**UNITED STATES ENVIRONMENTAL PROTECTION AGENCY**

Re: BP America Production Company  
Florida River Compression Facility  
Title V Permit – Renewal #1  
# V-SU-0022-05.00

**Enclosure - Response to Comments on the Florida River Compression Facility's  
March 28, 2008 Draft Title V Permit to Operate**

BP America Production Company  
 Florida River Compression Facility  
 Gas System Flow Diagram

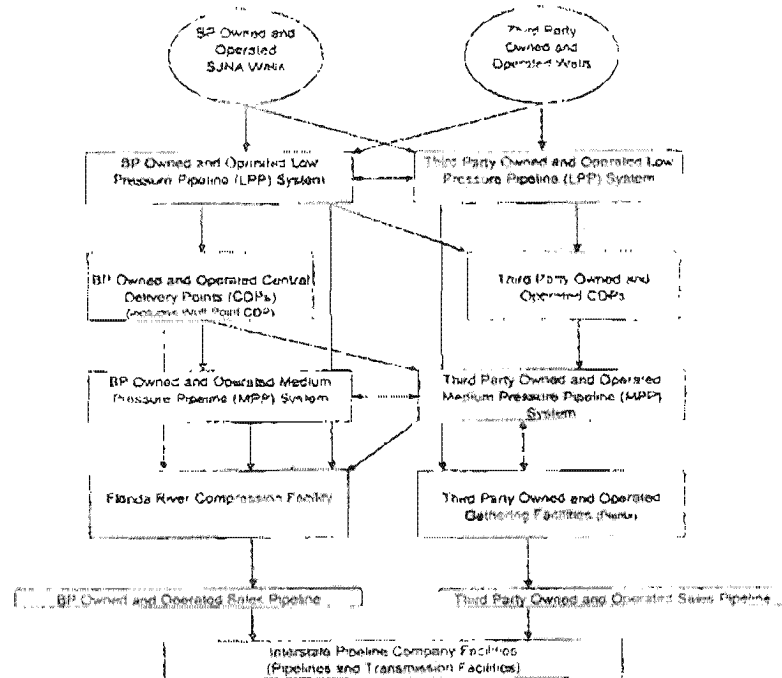
“BP gas” is transferred to third parties or vice versa, the gatherer takes custody of and assumes liability for the gas while in the gatherer’s possession, the gas is measured by the gatherer, and the shipper verifies those volumes with its own check meter.<sup>28</sup> The following process flow diagram illustrating the flow of gas in the field demonstrates the lack of a unique connection between BP facilities.<sup>29</sup>
